MIL-C-48670 (AR)
AMENDMENT 3
23 February 1989
SUPERSEDING
AMENDMENT 2
18 November 1987

MILITARY SPECIFICATION

CHARGE ASSEMBLY FOR M207E5 OR M207E6 WARHEADS
INERT PARTS, FOR

Figure 1

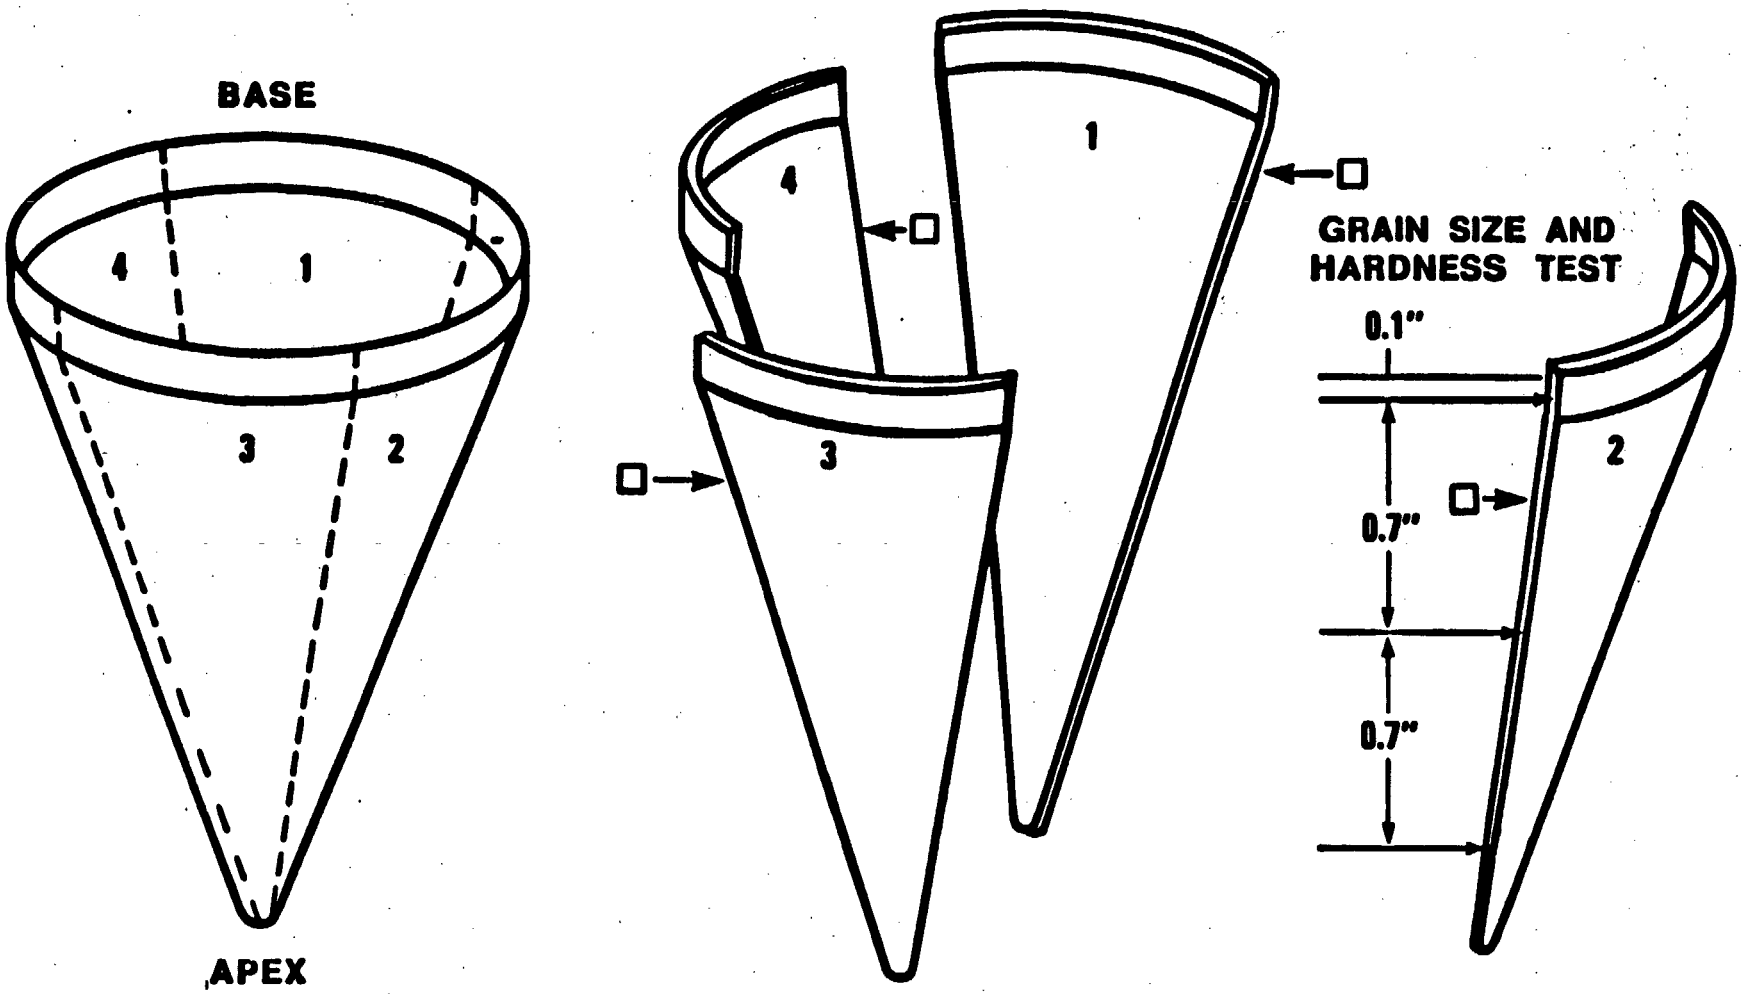
"The hardness of the finished liner shall be determined in accordance with ASTM-E-384. Three 1000g Knoop microhardness measurements shall be taken at the following locations: 0.10 inch, 0.80 inch, and 1.5 inches from the base (See Figure 1)."

"Two quarter test sections, 90 degree apart, from 4.6.4 shall be utilized for taking grain size. Examination shall be made at the same three locations which were hardness tested (see Figure 1)."
